Subject: Final Corrective Measures/Feasibility Study Work Plan
PG&E Topock Compressor Station, Needles, California

Corrective Measures/Feasibility Study Work Plan

Appendix A
Response to Agency Comments on the Draft
Topock Corrective Measures/Feasibility Study
Work Plan

EXHIBIT 1-2
CMS/FS Process Overview

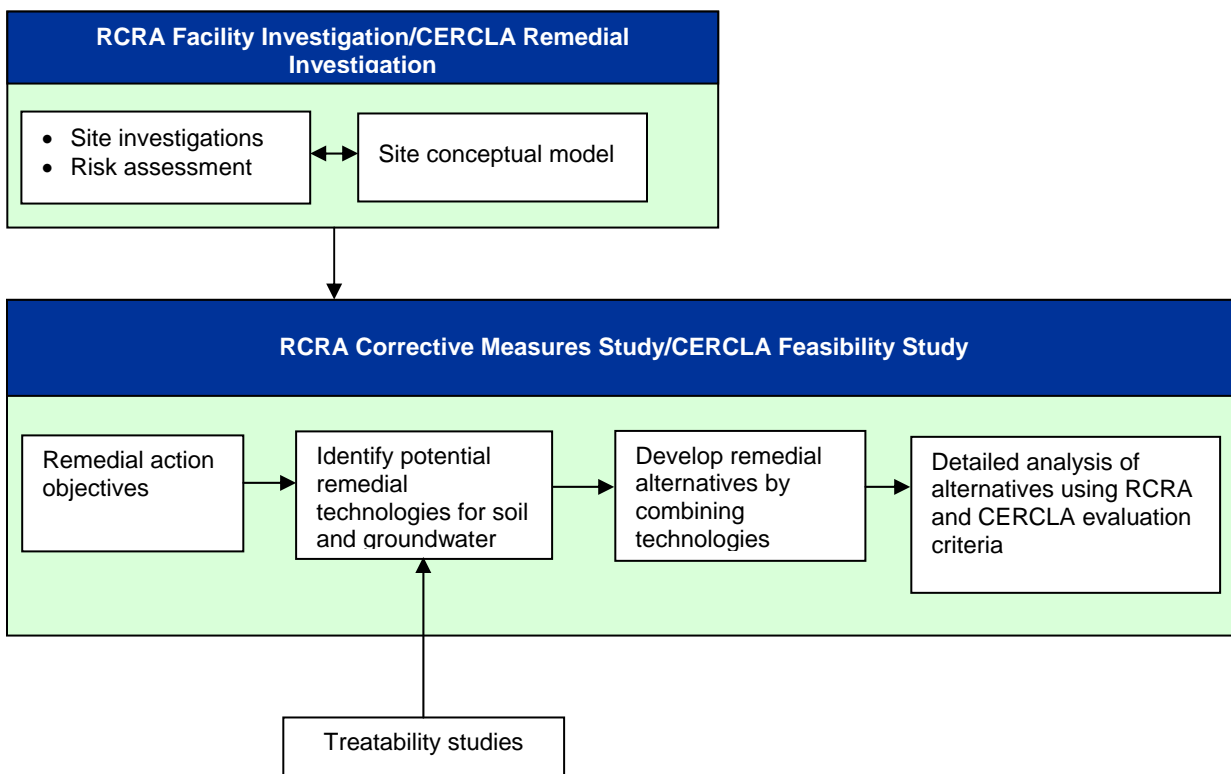
U.S. Department of the Interior	DOI-8	Sec. 1.3, Exhibit 1-2, Page 1-4	The Conceptual Site Model (CSM) is generally initiated during the DQO process and refined during the risk assessment. The intent of the RFI/RI is to fully characterize the site which includes the finalization of the conceptual site model. The first block of the diagram doesn't present this approach.	The comment is correct that the risk assessment and RFI/RI refine and finalize the site conceptual model. The first block in the diagram is intended to illustrate this; the site conceptual model is refined based on results from the site investigations and the pathways and receptors included in the risk assessment.	The final CSM should be agreed to by the decision -makers prior to initiating the CMS/FS. PG&E should describe the process for obtaining agreement from decision-makers on the final CSM.		Section 2.3 has been revised in response to this comment to add the following sentence: "The final conceptual site model will be documented in the forthcoming RFI/RI and risk assessment. PG&E will submit the RFI/RI and risk assessment to DTSC and DOI for approval of the final conceptual site model prior to initiating the CMS/FS."

U.S. Department of the Interior	DOI-9	Sec. 1.3, Exhibit 1-2, Page 1-4	Where do ARARs fit into this process? This section should be revised to incorporate the regulatory requirement for ARARs within the CERLCA process. (ref. CERCLA Section 121(d) and	As discussed in Section 3.0 of the CMS/FS work plan, ARARs are used to guide the development of the media cleanup goals and standards. Also, as discussed in Section 5.0 of the CMS/FS work plan, compliance with ARARs is an evaluation criteria that will be used in the CMS/FS evaluation process	Be sure this response is reflected in the text		No changes to the work plan have been made in response to this comment. ARARs are discussed in the CMS/FS work plan in Sections 3.0 and 5.0.

EXHIBIT 2-1
CMS/FS Process—Site Conceptual Model

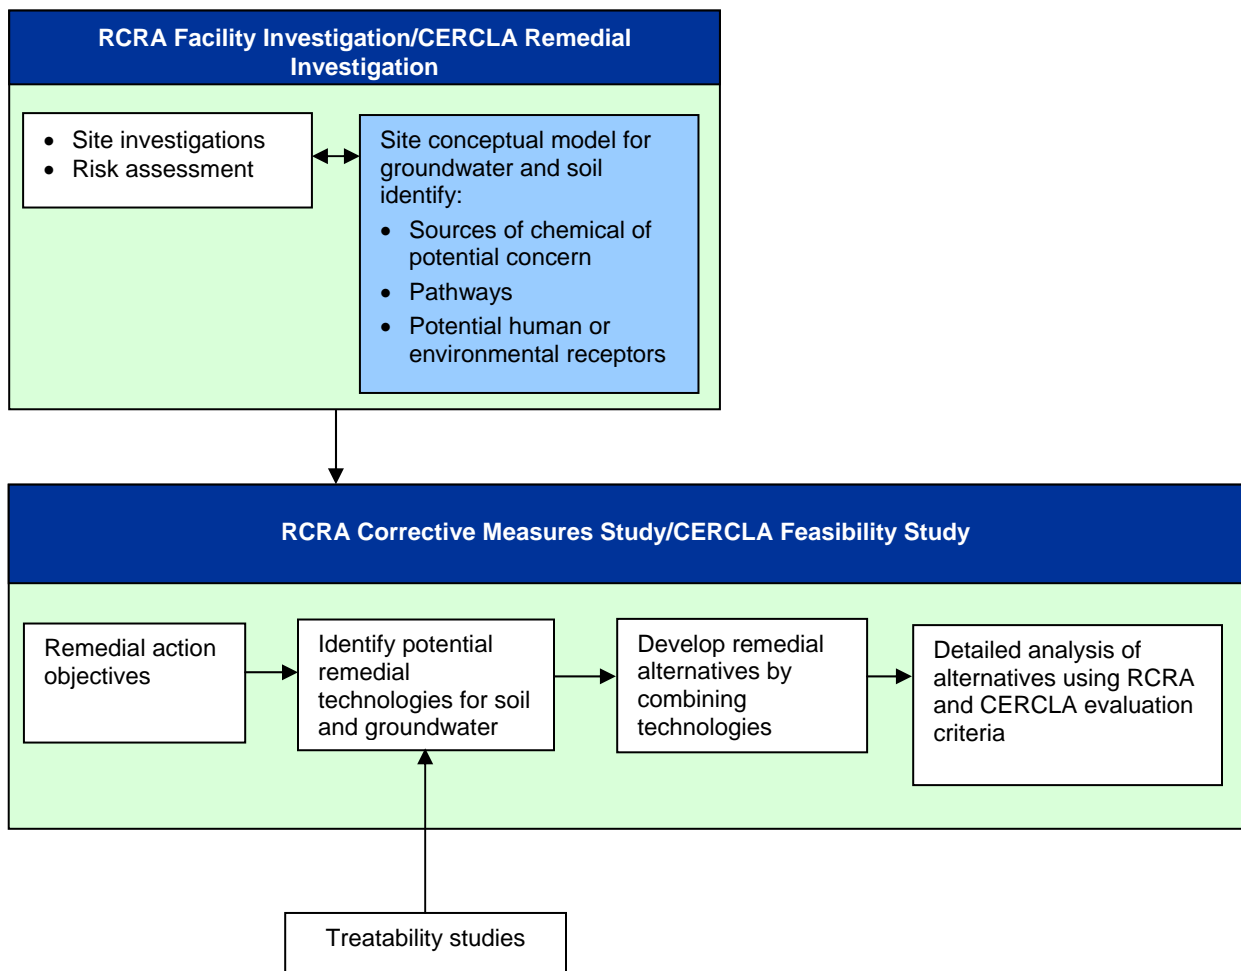
Section 2							
U.S. Department of the Interior	DOI-10	Sec. 2.0, Exhibit 2-1, Page 2-1	The initiation of the CSM should be during the planning stages and refined as additional information is collected. This iterative approach will serve to direct the investigation to meet the requirement of an adequate and detailed site characterization. Please provide additional clarification on the development of the CSM.	The purpose of Exhibit 2-1 is to illustrate how the conceptual model fits with the CMS/FS process. Details about the development of the various specific aspects of the site conceptual model are not necessary for this purpose. The comment is correct that the site conceptual model is initiated during the planning stages and refined as additional data are collected. The site conceptual model information provided in the CMS/FS work plan for the Topock site is intended to be a summary of the physical processes associated with the release and potential migration of site related compounds based on currently available information. It is acknowledged that the site conceptual model will be refined and finalized in an iterative manner as additional data are collected during the RFI/RI. Additional refinements will be presented in the risk assessments documents as the relevant human and ecological receptors and their potential exposure pathways are identified.		DTSC agrees with PG&E's response. However, the CMS/FS Work Plan should be clear on the decision logic as to how this iterative process works, and how new information will be incorporated into the CSM.	Section 2.3 has been revised in response to this comment. The following sentences have been added: “The site conceptual model for the Topock site will be refined from that presented in this section following completion of the additional investigations. The final site conceptual model will be documented in the forthcoming RFI/RI and risk assessments. The CMS/FS will reiterate the conceptual site model developed in the RFI/RI and risk assessments, as refined based on the additional site investigation and risk assessments, as well as any new information developed after the final RFI/RI report is prepared that could significantly affect the evaluation and selection of remedial alternatives.”

Agency	Comment Number	Section	Comment	Response	DOI Direction	DTSC Direction	Work Plan Revisions
Department of Toxic Substances Control	DTSC-3	Page 2-1, Exhibit 2-1	The exhibit suggests that the site investigation and the risk assessment provide the initial steps to the Site Conceptual Model. The reality is probably more of an iterative process to refine the Site Conceptual Model leading to a good predicative risk assessment to derive at the Remedial Action Objectives.	As discussed in response to comment DOI-8 and MWD-2, the site conceptual model is initiated during the planning phases but is refined based on the results of the site investigations and objectives of the risk assessment. The comment is correct that the development and refinement of the site conceptual model is iterative. However, the final site conceptual model is derived from the results of the site investigations and modifications presented in the risk assessment that incorporate the receptors and exposure pathways identified during that evaluation step.		DTSC agrees with PG&E's response. However, the CMS/FS Work Plan should be clear on the decision logic as to how this iterative process works, and how new information will be incorporated into the CSM.	Section 2.3 has been revised in response to this comment. The following sentences have been added: "The site conceptual model for the Topock site will be refined from that presented in this section following completion of the additional investigations. The final site conceptual model will be documented in the forthcoming RFI/RI and risk assessments. The CMS/FS will reiterate the conceptual site model developed in the RFI/RI and risk assessments, as refined based on the additional site investigation and risk assessments, as well as any new information developed after the final RFI/RI report is prepared that could significantly affect the evaluation and selection of remedial alternatives."

EXHIBIT 4-7

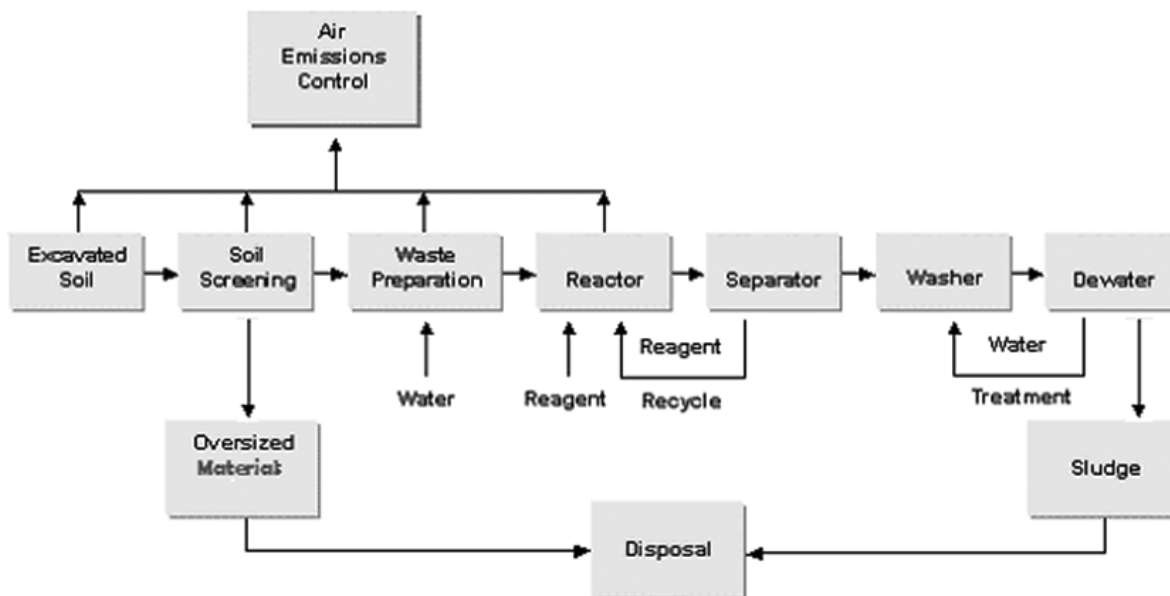
Department of Toxic Substances Control	DTSC-19	Page 4-10, Section 4.2.2.2	The soil screening box in Exhibit 4-7 should have the arrow directed to the oversized material box. The arrow from the dewatering step should be directed to the sludge box.	The comment is correct that the two arrows in the exhibit should be reversed (from soil screening to oversized materials, and from dewater to sludge).			No DTSC or DOI direction to modify the CMS/FS work plan in response to this comment. The arrows in Exhibit 4-7 have been modified.
Department of Toxic Substances Control	DTSC-20	Page 4-11, Section 4.2.3	Two primary requirements for soil flushing should be listed: (1) the flushing solution must be effectively transported so as to contact the impacted soil and remove the contaminant; this is not identified as a key requirement for this technology's success, and (2) groundwater can be captured, extracted, and treated (this is stated in the Work Plan).	The comment correctly identifies the primary requirements for successful soil flushing.			No DTSC or DOI direction to modify the CMS/FS work plan in response to this comment.

**FIGURE 2-1
TOPOCK SITE HYDROGEOLOGIC
FEATURES**
CORRECTIVE MEASURES/FEASIBILITY STUDY WORK PLAN
PG&E TOPOCK COMPRESSOR STATION
NEEDLES, CALIFORNIA

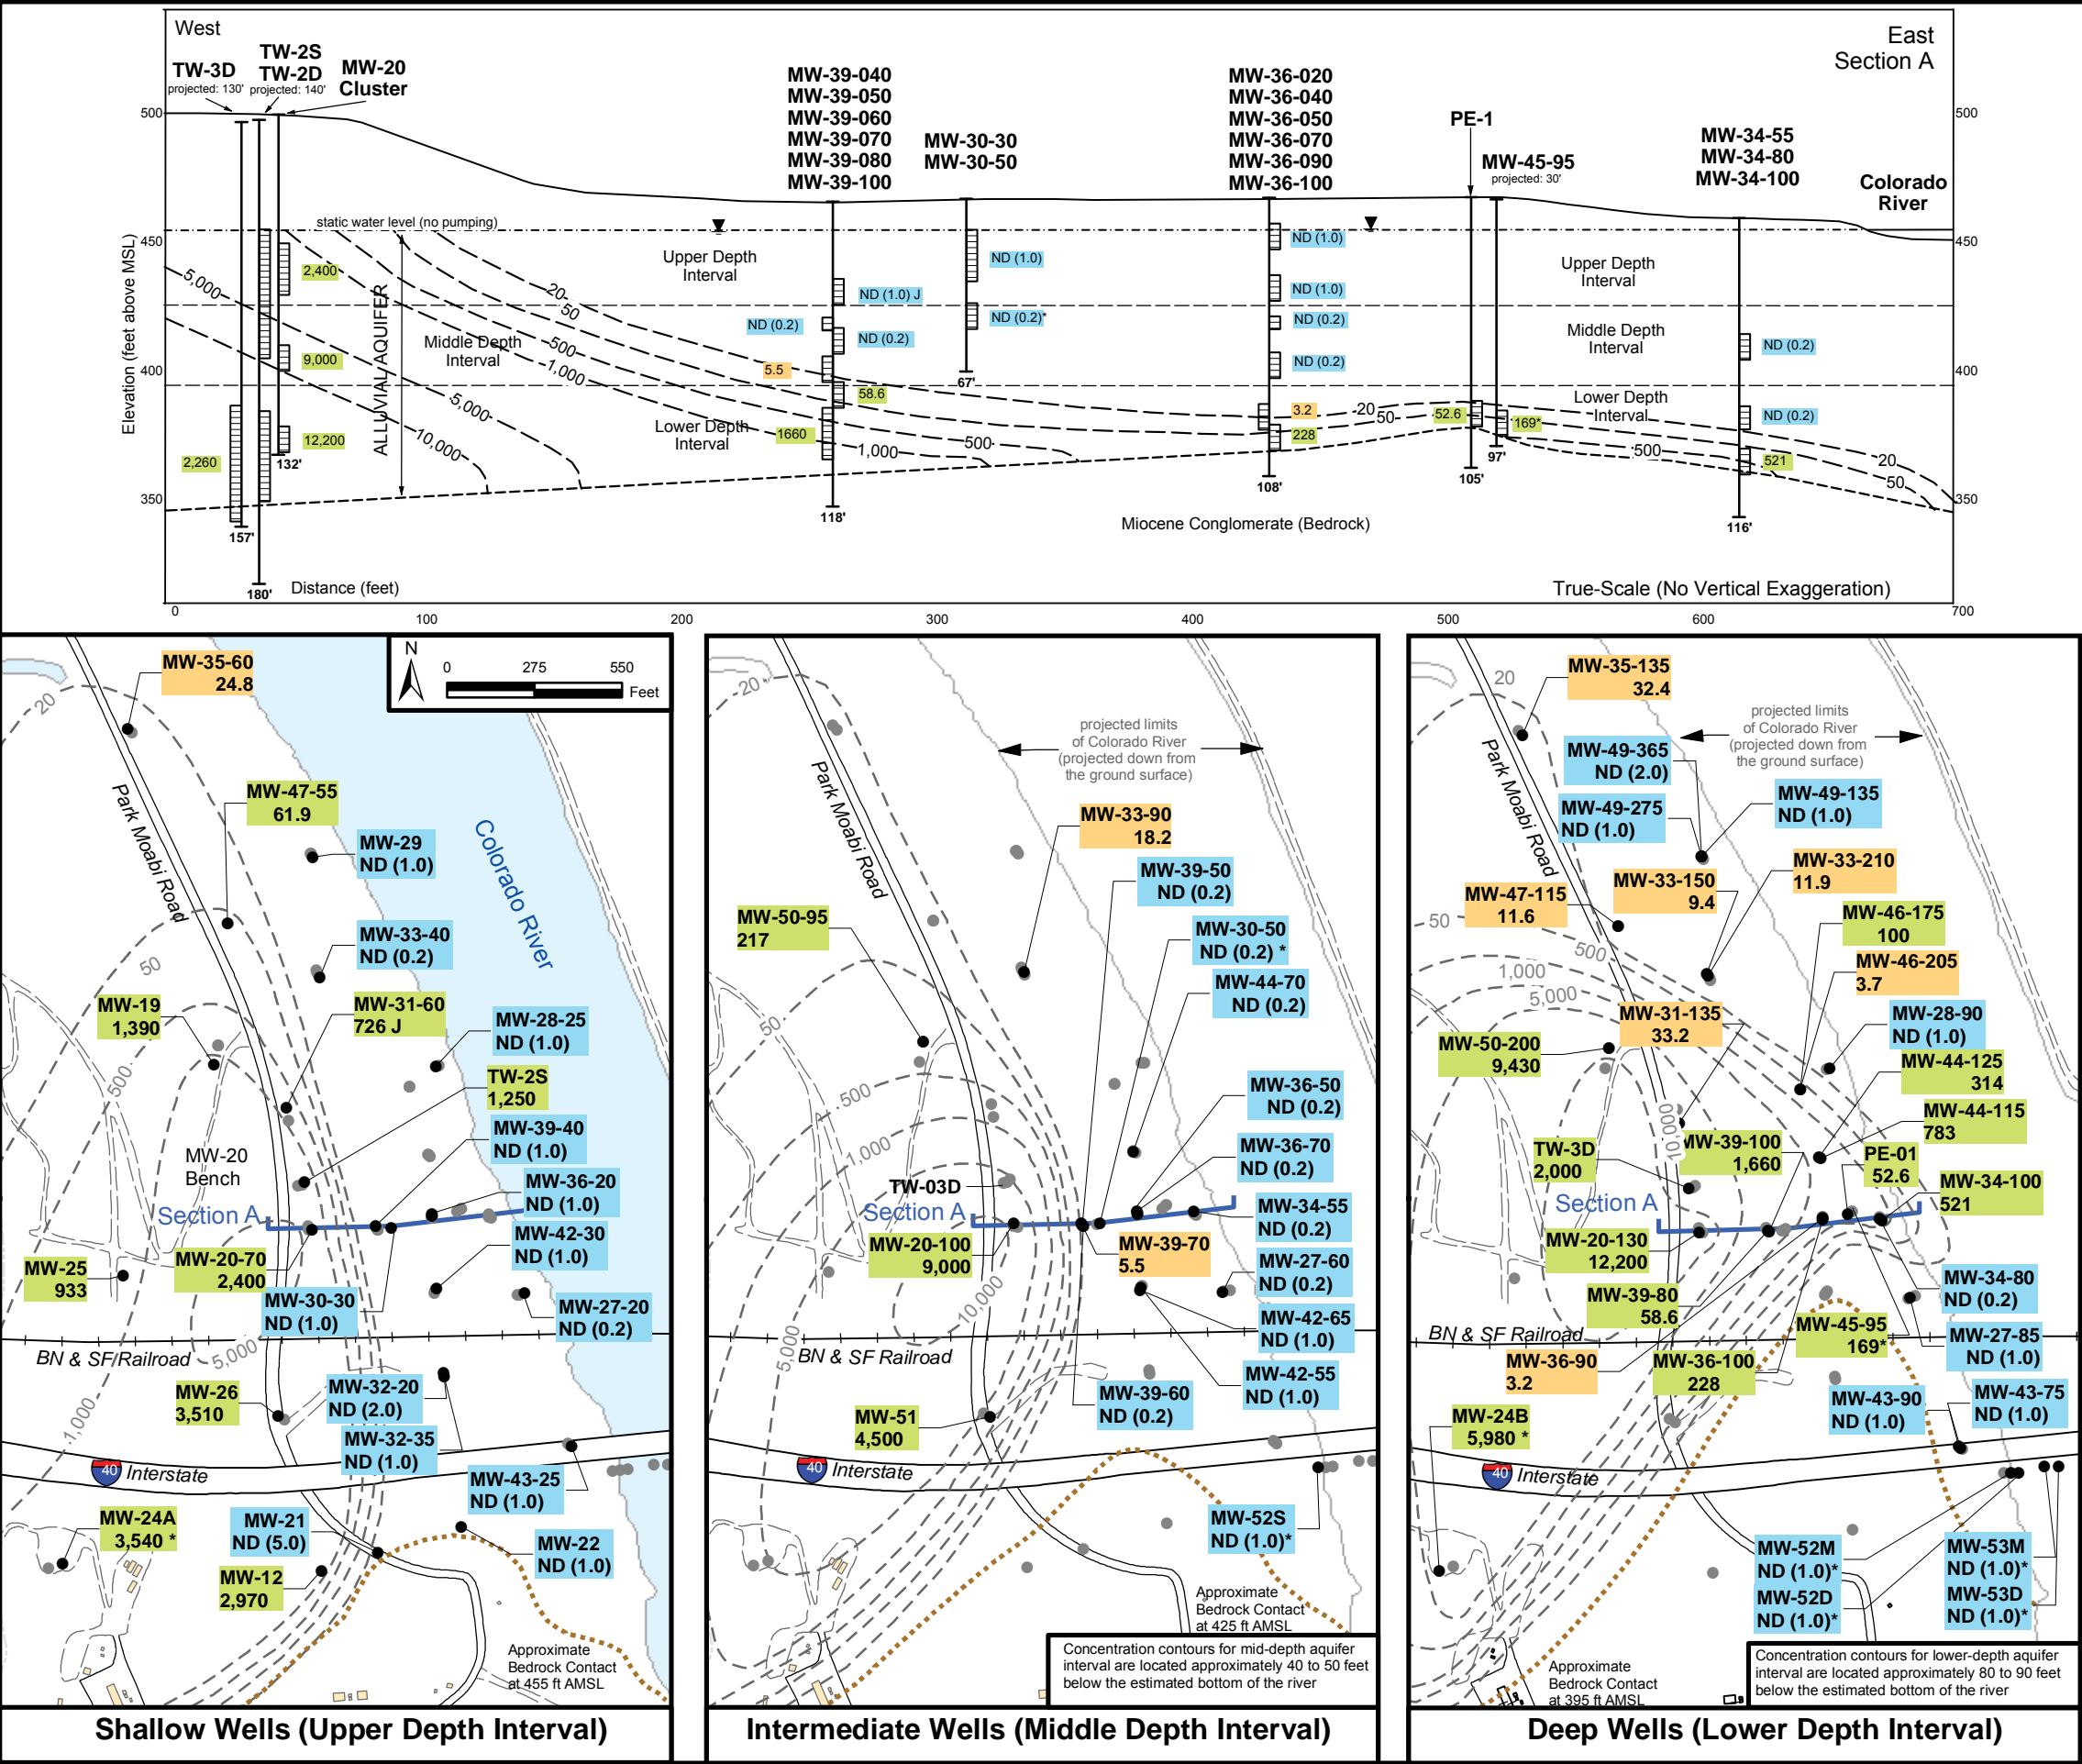
U.S. Department of the Interior	DOI-11	Figure 2-1 and Secs. 2.1.1 and 2.1.2, Page 2-2	The CSM presented in the figure does not illustrate the other potential sources of contamination. It focuses on the percolation beds in Bat Cave Wash without considering other potential and uncharacterized sources. Please revise the CSM to illustrate other potential sources and make it consistent with other CSMs developed during the DQO process.	It should be clarified that Section 2.1 and Figure 2-1 of the CMS/FS focus on the conceptual model associated with the historic practice of wastewater discharge to Bat Cave Wash. This is a known source of groundwater contamination for which extensive characterization has been performed. If any of the other historic operations at the Topock Compressor Station have affected groundwater, these activities would likely be secondary sources due to the relatively low quantities released, types of materials managed, depth to groundwater, and precipitation rates at the site. While the effect on groundwater of other historic operations at the Topock Compressor Station is considered secondary to the historic practice of wastewater discharge to Bat Cave Wash, characterization of these other potential sources is planned and will be included in the forthcoming RFI/RI Volume 3. The conceptual site model to be presented in the CMS/FS will incorporate the data developed from the characterization of these other sources.	Add statement within section that acknowledges other sources of contamination may be possible and will be documented in CSM following completion of RFI/RI	DTSC agrees with this response as long as the text of the CMS/FS Work Plan is modified to incorporate this idea.	The last sentence in Section 2.1.1 has been modified in response to this comment and states: "Other COPCs and sources to groundwater may be identified as ongoing investigations are completed and will be documented in the RFI/RI." The seventh sentence in the first paragraph in Section 2.1.2 has been modified in response to this comment and states: "As investigation of additional sources proceeds, new data are collected from existing wells, and new wells are installed, the plume will be more precisely defined."
